Addenda No. 2

SUBJECT: OR7: Dewey Ave. UPRR U'xing (Baker City) Section
Whitney Highway
Baker County
Structure and Paving Project
(Bids to be opened and read April 30, 2009)

OR7: Dewey Ave. UPRR U'xing (Baker City) Section
 Whitney Highway
 Baker County
 Structure and Paving Project
 (Bids to be opened and read April 30, 2009)

SHEET NO.
GA

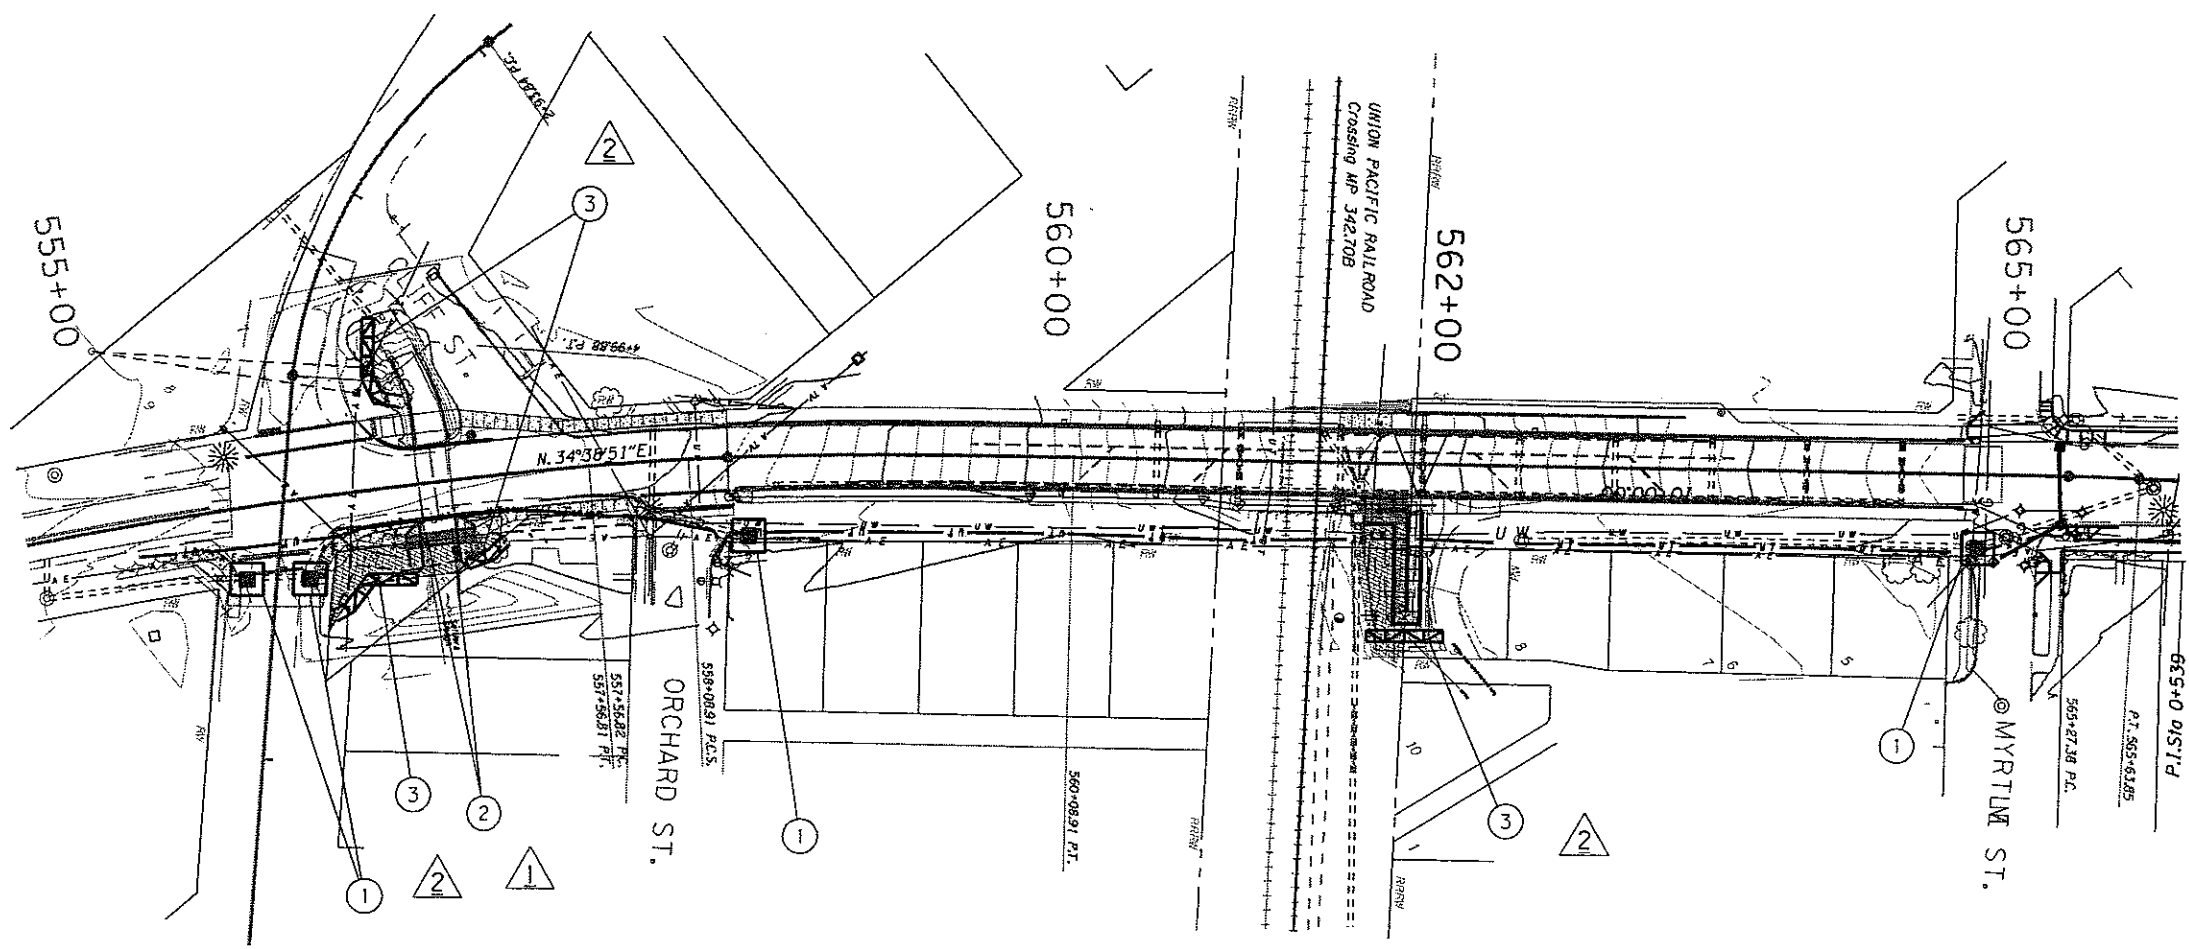
①	Revised 04-17-09 Added note
②	Revised 04-17-09 Added note

STRUCTURE NO. 21140	PEDESTRIAN OVER SETTLERS SLOUGH HWY 71 OR7; DEWEY AVE. UPRR U'XING (BAKER CITY) SEC. WHITNEY HIGHWAY BAKER COUNTY	SHEET 1 OF 6
DATE March - 2009	PLAN AND ELEVATION	DRAWING NO. 81710
CALC. BOOK NA

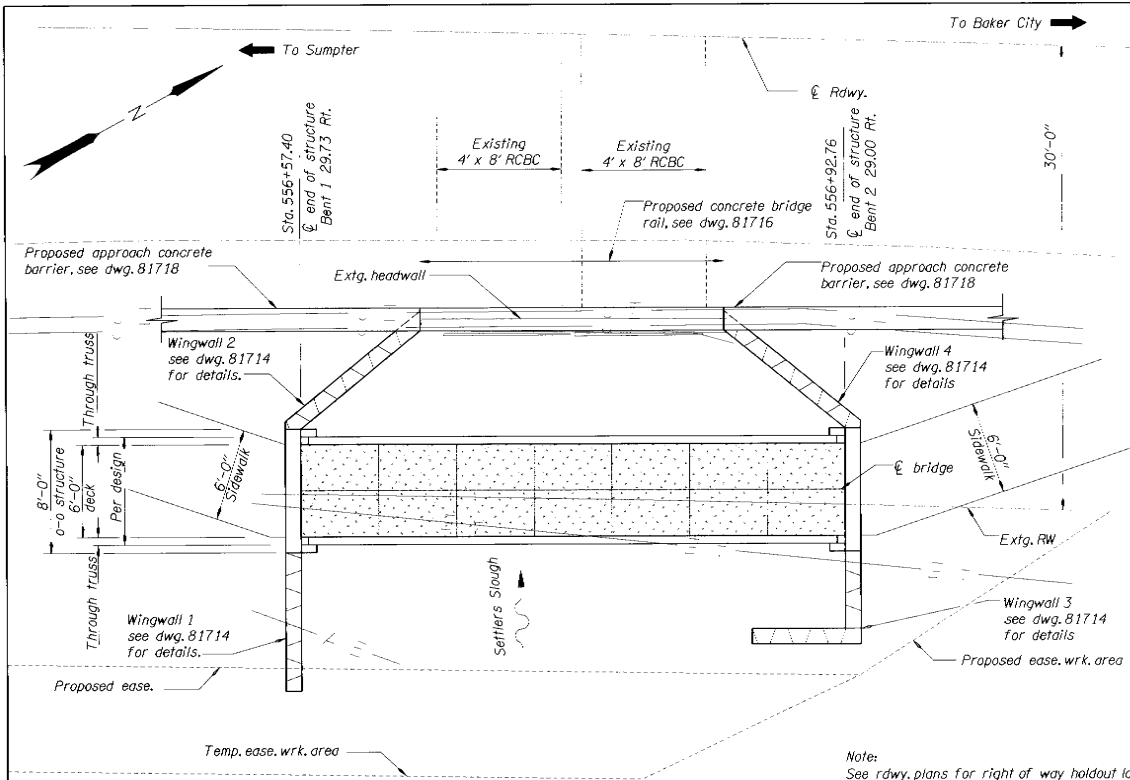
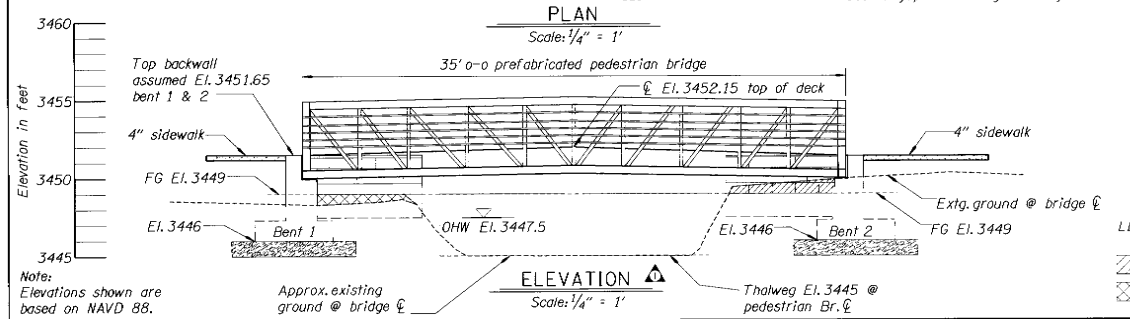
DATE	REVISION	BY
04-17-2009	Elevation view labels	RM
04-17-2009	change hydraulic data note	RM

PEDESTRIAN OVER SETTLERS SLOUGH HWY 71
 OR7: DEWEY AVE. UPRR CROSSING (BAKER CITY) SEC.
 WHITNEY HIGHWAY
 BAKER COUNTY
 FOOTING PLAN

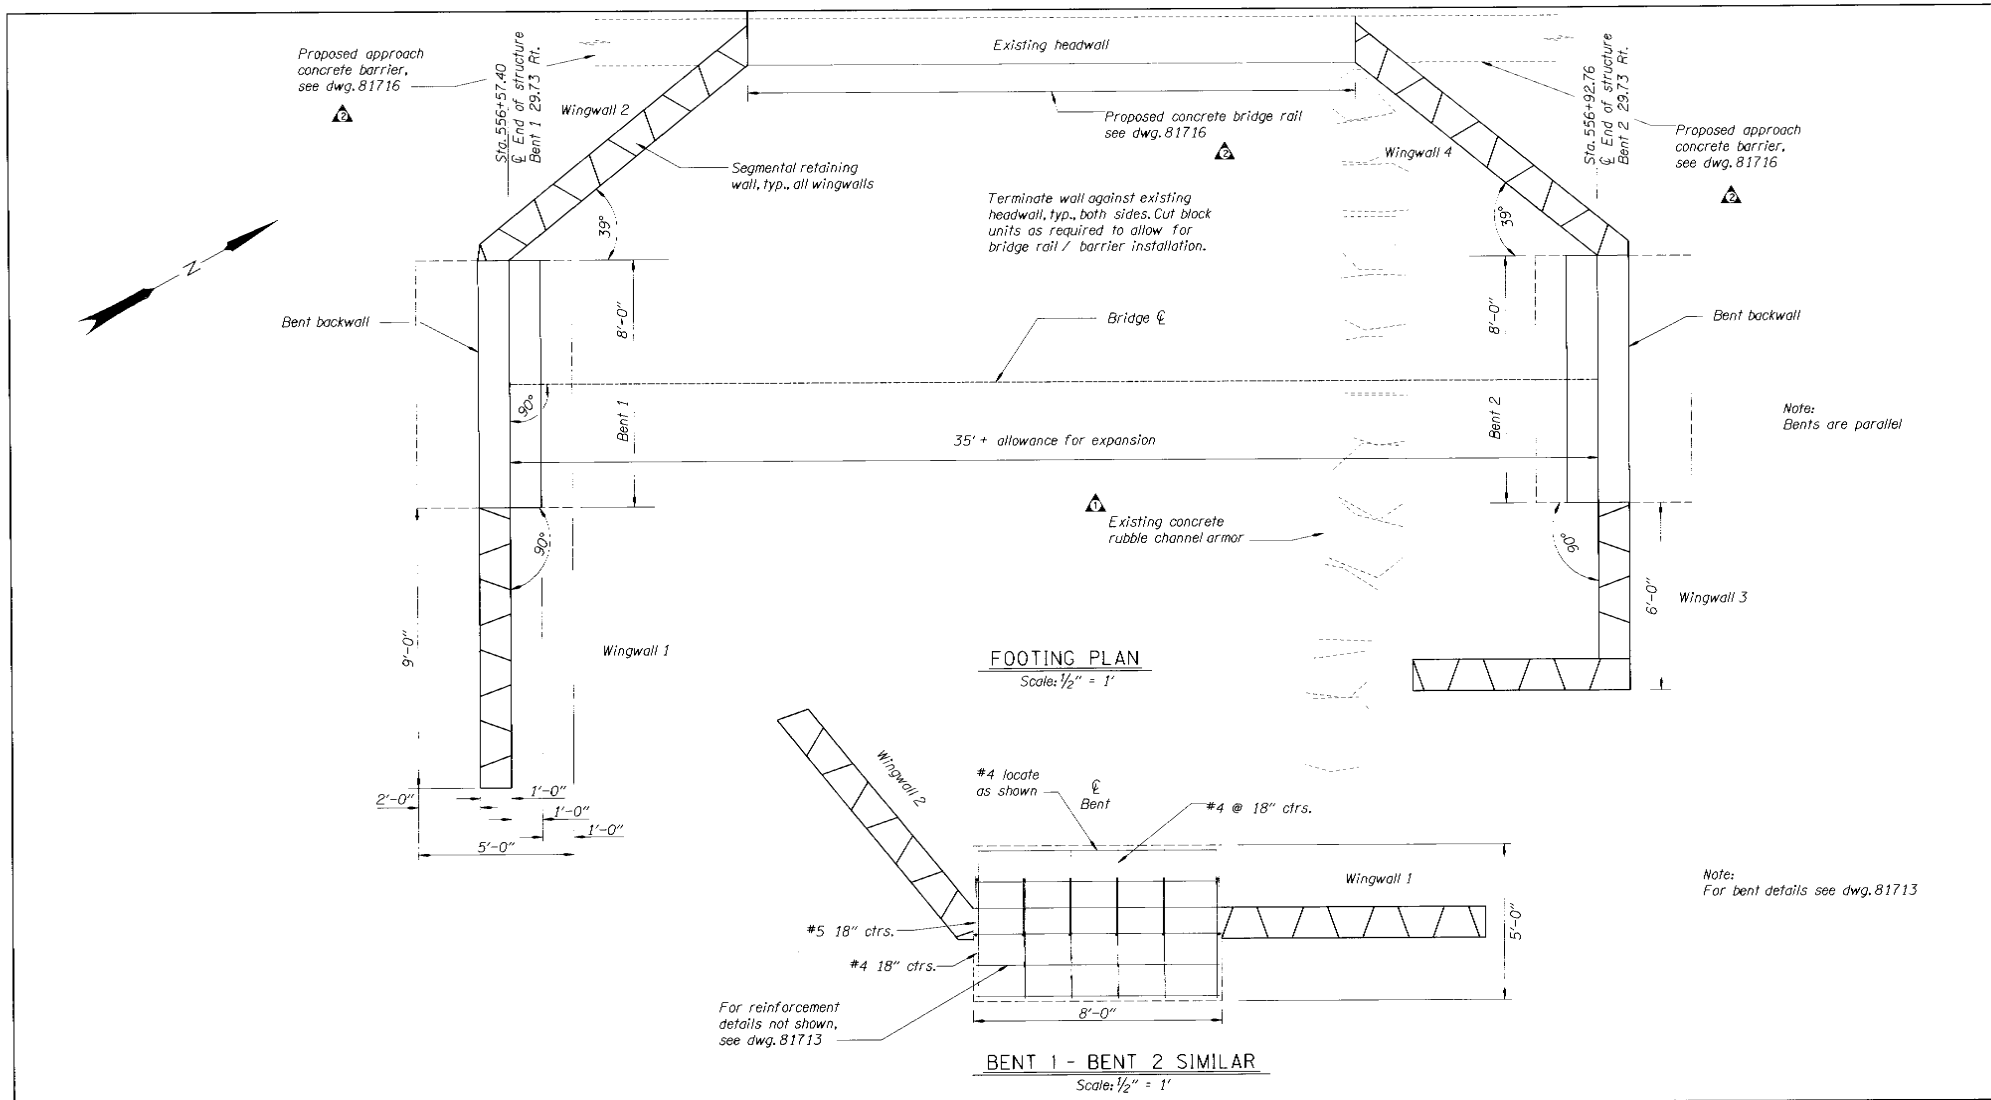
REVISION	DATE	REVISION	BY
1	04-17-2009	Add concrete rubble channel armor	RM
2	04-17-2009	Change cwg coil out	RM
